**\*MANDATORY SERVICE BULLETIN\*****NUMBER:** SB14-03**REVISION:** 01**DATE:** June 12, 2014

**SUBJECT:** TKS™ CONSOLE TANK LEVEL INDICATOR INSTALLATION

Document #:	Document Title:
FSI-088	TKS™ CONSOLE TANK LEVEL INDICATOR INSTALLATION

TITLE: TKS Console Tank Level Indicator Installation  
SERIAL RANGE: As Required

**Figure 5-1: Console Tank**

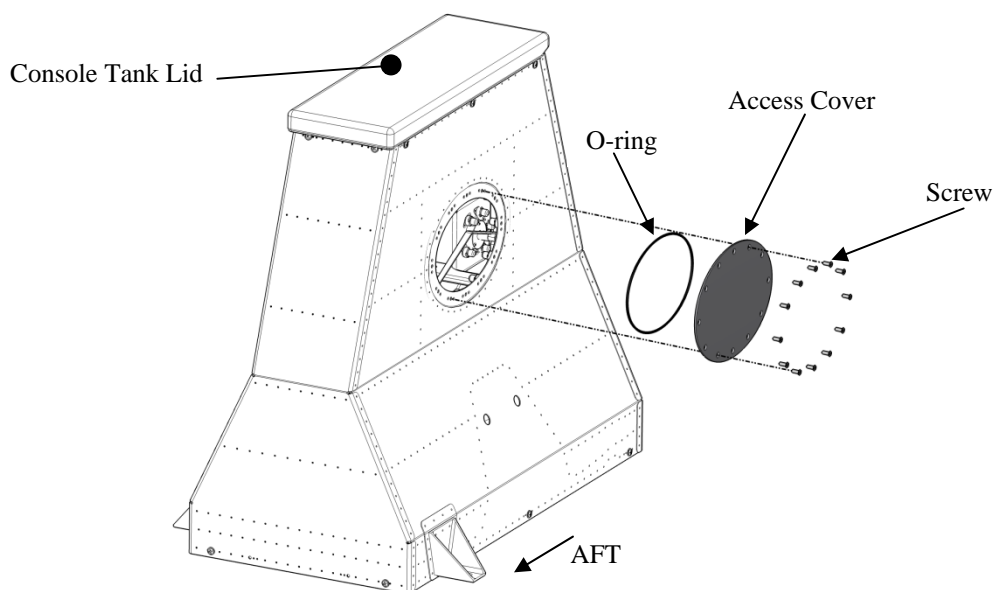
1. Open the access cover on the right side of the console tank by removing twelve (12) screws (**Figure 5-1**).

Use caution when removing the access cover to prevent damage to the o-ring. If damage occurs, contact Quest Aircraft Customer Service, or replace with item listed in **Table 2-4-3**.

**Figure 5-2: Filler Cap Ring**

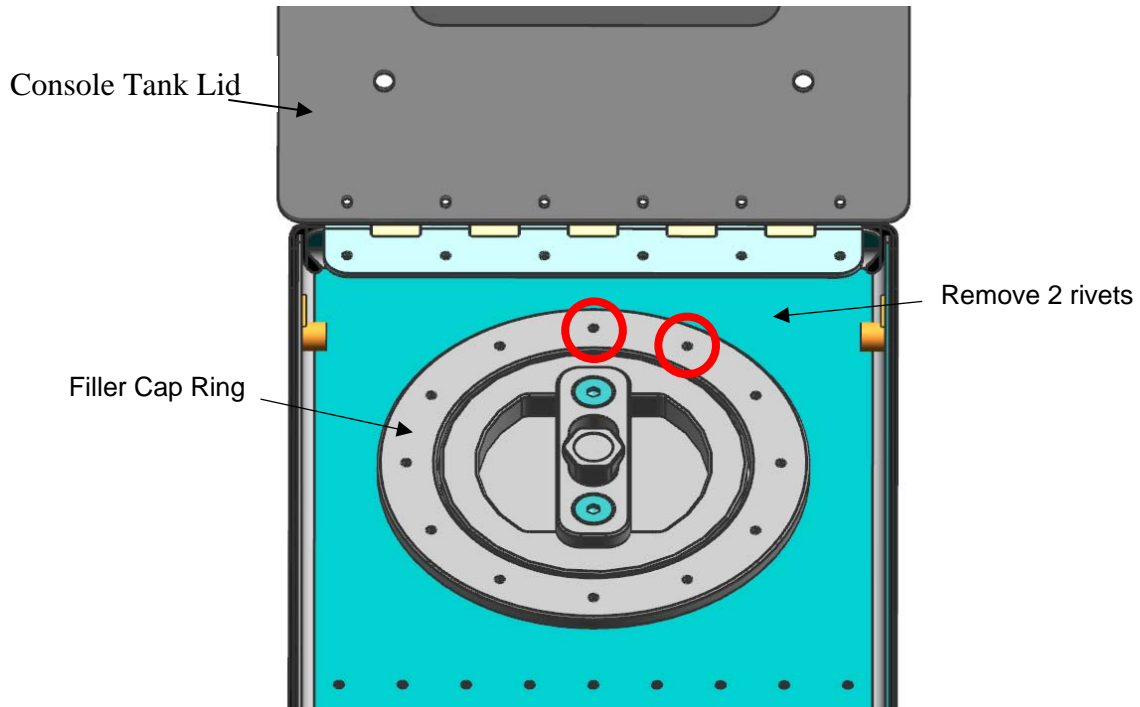
3. While covering the inside end of each rivet, drill out the two rivets in the filler cap ring shown in **Figure 5-2**.

**Figure 5-3: Fluid-Level Indicator**

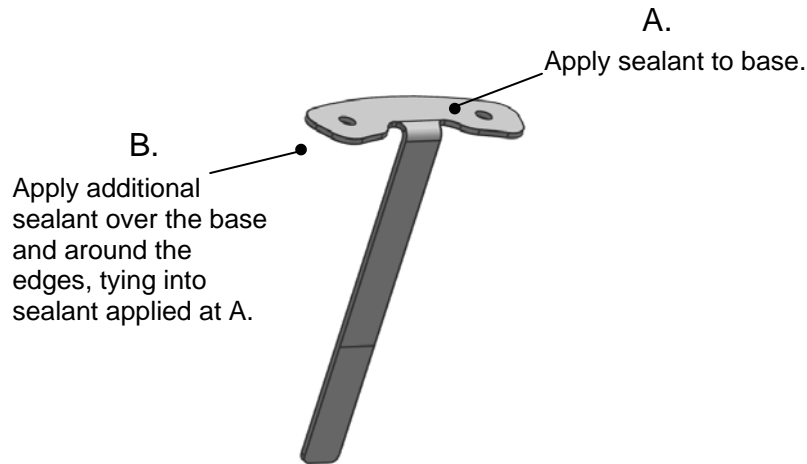
1. Apply ProSeal 890 (or any sealant meeting the requirements of SAE AMSS8802 Class A) to the base of the fluid-level indicator (P/N 100-830-1999) (**Figure 5-3(A)**).
2. From within the tank, align the fluid-level indicator with the rivet holes drilled out in Section 5.1.
3. Wet install two rivets (P/N MS20470AD3-5.5).
4. Clean up any squeeze-out sealant visible on the top of the filler cap ring.
5. Apply sealant over the base of the fluid-level indicator, around the edges, and the area around the fluid-level indicator to tie into the existing sealant (**Figure 5-3(B)**).

**Figure 5-4: Access Cover Reinstallation**

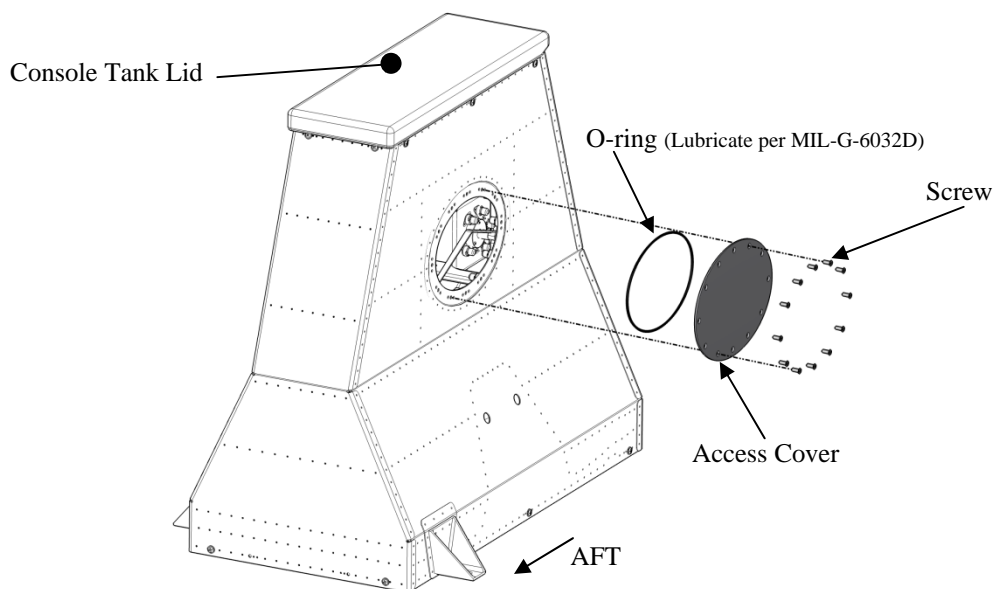
6. Allow the entire assembly to dry 24 hours or until the sealant is fully cured.
7. Inspect the console tank fluid for debris. If debris is present, remove and flush the strainer, and reinstall in accordance with the *KODIAK® 100 Airplane Maintenance Manual*, Chapter 30.
8. Lubricate the access cover O-ring (P/N 10M620-1) with EZ Turn Fuel Lubricant (or other lubricant per MIL-G-6032D).
9. Reinstall the O-ring into the access cover (**Figure 5-4**).
10. Reinstall the access cover with 12 screws (**Figure 5-4**).

**Figure 6-1: Placard Installation**

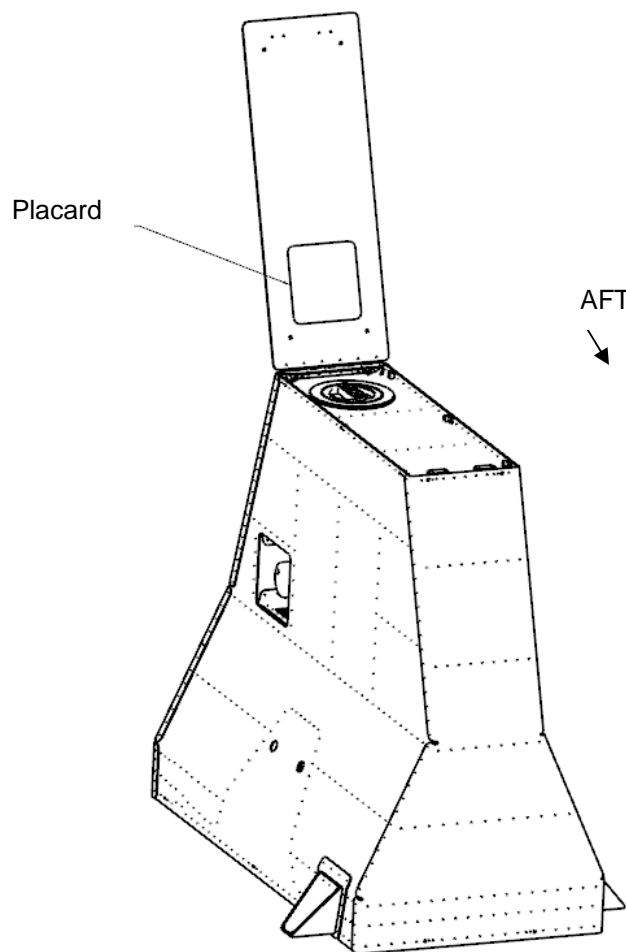
1. If the tank was removed from the airplane, reinstall the tank and connect the three hose fittings below the floor using two (2) new sealing rings (P/N 100-013-8810) and one (1) new O-ring (P/N S-1201-20).
2. Apply the placard (P/N 100-910-0118) to the inside lid of the console tank as follows:
  - a. Ensure that the surface where the placard is to be applied (**Figure 6-1**) is clean, dry, and free of grease, oil, or other lubricants and contaminants.
  - b. Peel placard from carrier sheet, center, and press firmly.
